MEMORANDUM

TO: District of Columbia Board of Zoning Adjustment
FROM: Arthur Jackson, Case Manager
Joel Lawson, Associate Director Development Review
DATE: October 29, 2013
SUBJECT: BZA Case 18633 – special exception and variance relief requested to allow renovation of a former apartment building located at 2826 Q Street SE for a community service center

Figure 1

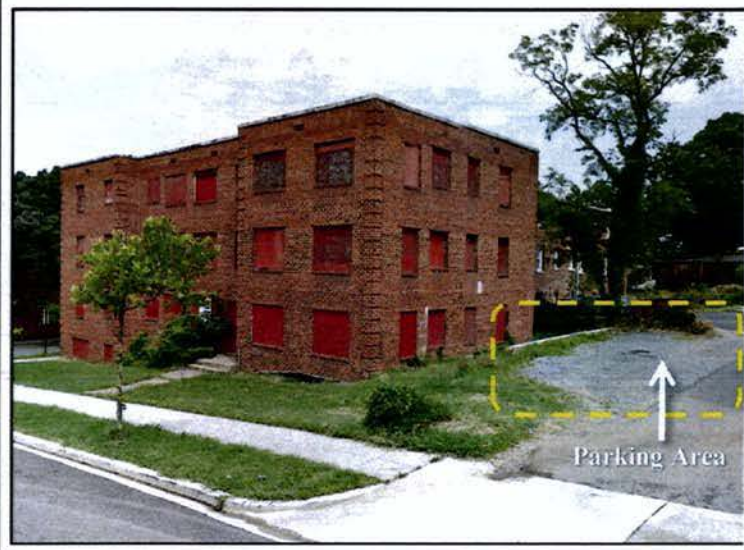
Lot Characteristics	The rectangular shaped corner lot of 5,166 square feet (0.12 acre approximately) with frontages along 28 th Place, Q Street SW and a public alley 15 feet wide that extends north from Q Street. The property slopes down from the eastern boundary toward 28 th Street SW (reference Figures 1 and 2)
Zoning	R-5-A – a community service center is allowed with special exception approval
Existing Development	According to the application, the property is developed with a three-story apartment building <i>constructed in 1942</i> that has been vacant for 22 years (since 1991). Building facades sit on the southern and western property boundaries and a paved parking pad wide enough for five vehicles extends along the entire eastern boundary of the site (reference Figures 1 and 2)
Historic District	None
Adjacent Properties	Occupied apartment buildings of similar scale on three sides and two-story and two story, semi-detached dwellings to the west across 28 th Street SE

The current orientation of the building, with the front entrance along Q Street SE and location of existing parking off the alley, would remain the same as it has been for decades. The property is immediately accessible to the adjacent streets. According to the application, the building interior is being renovated to accommodate all center program activities. Based on this information, activities associated with center program should not create any objectionable conditions in the neighborhood.

Adding an approval condition limiting the use of the building and site to service program activities of the NCC would help ensure this continues to be the case.
